SERVICE BULLETIN

NUMBER: 12-288-20
DATE: 05/05/20

SUBJECT: Power Front Seat Cushion Frame / Slide Rail- Design Change

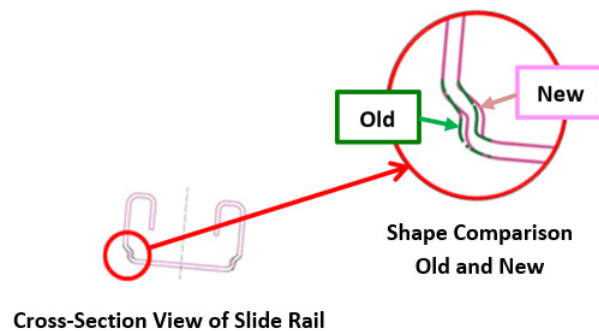
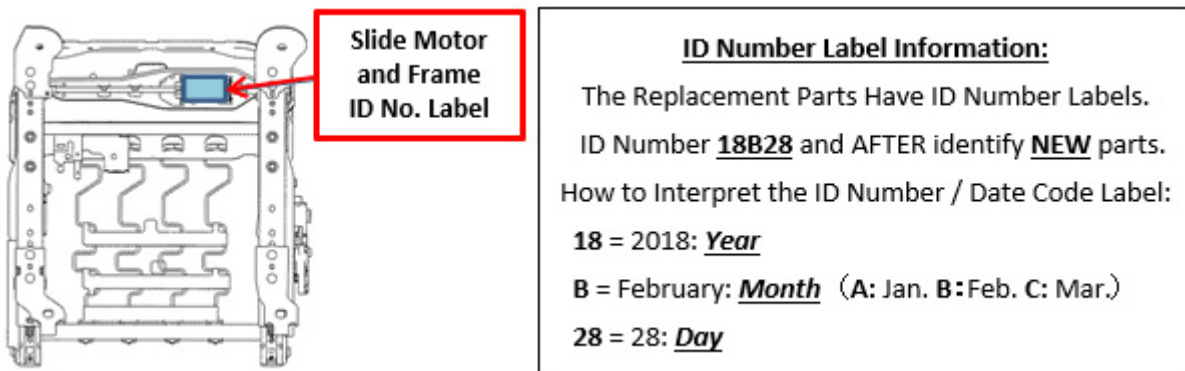
- This illustration shows the design change made to the shape of the Slide Rail.

- The information below instructs how to confirm the replacement seat frame assembly contains the new Slide Rails.
